1971 Corvette: Service Bulletin: Anti-Diesel Relay

Subject: Anti-Diesel Relay

Source: Chevrolet Dealer Service Technical Bulletin

Bulletin No: 71-T-44

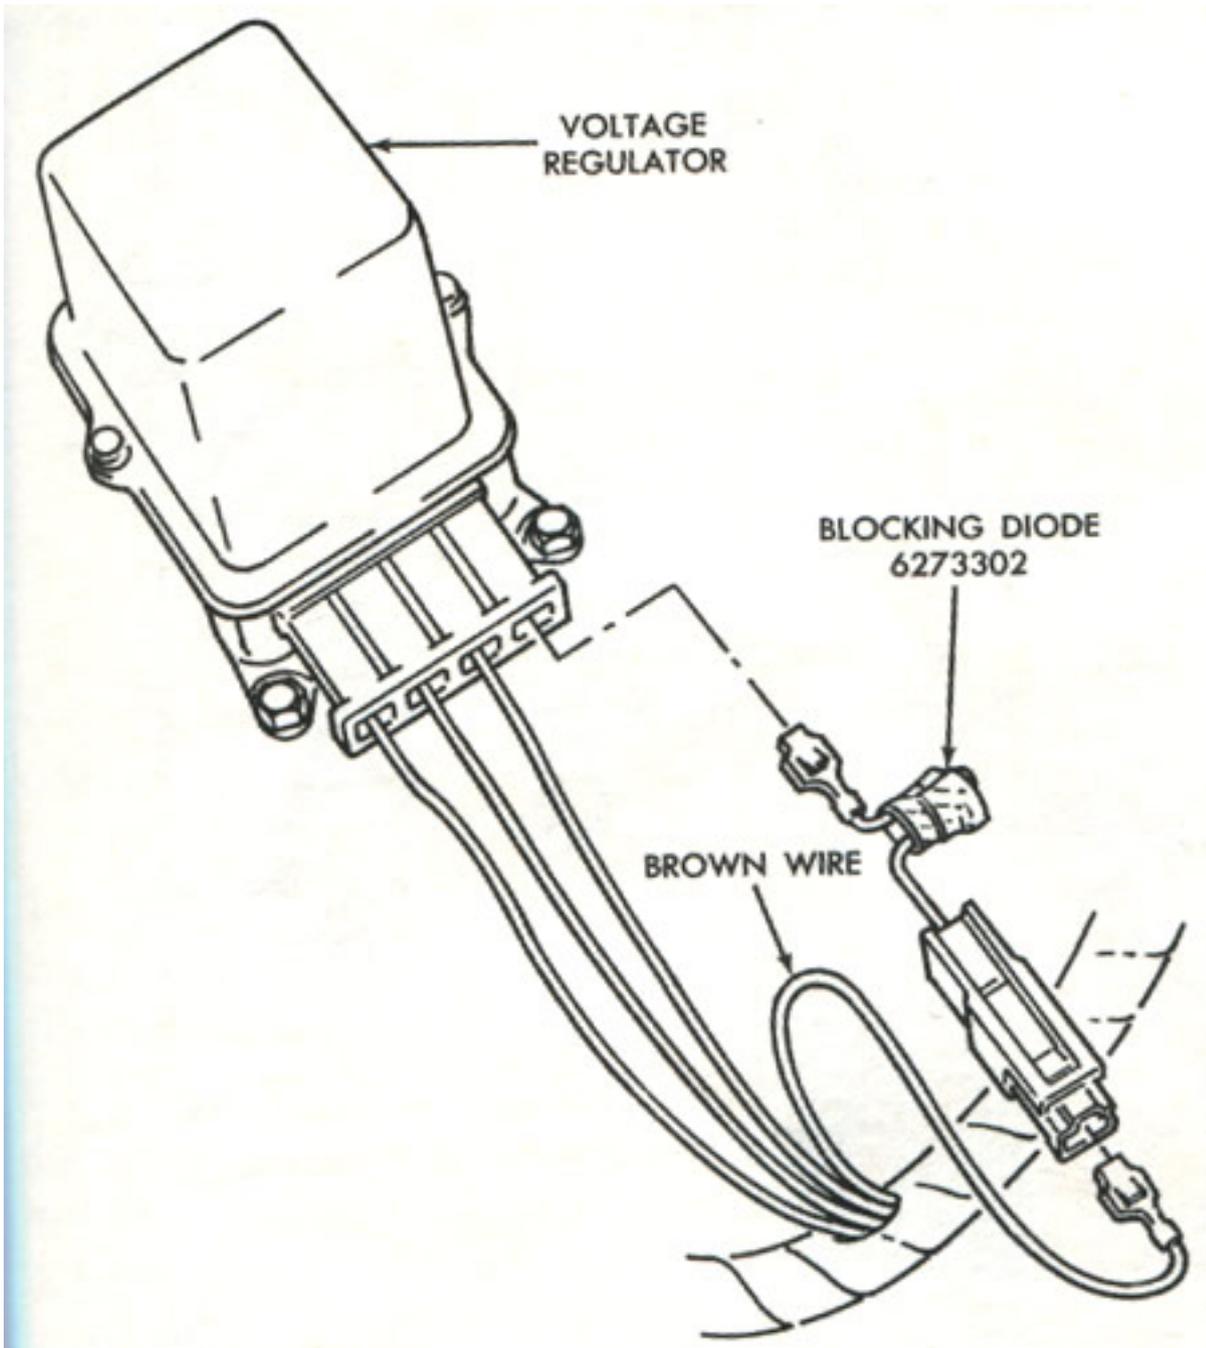
SERVICE PROCEDURE - TRUCK

Blocking Diode Installation

1. Disconnect wiring harness from voltage regulator.
2. Remove brown wire from the plastic connector.
3. Install the blocking diode between the voltage regulator connector and the brown wire as illustrated in Figure 1.
4. Connect harness to voltage regulator.
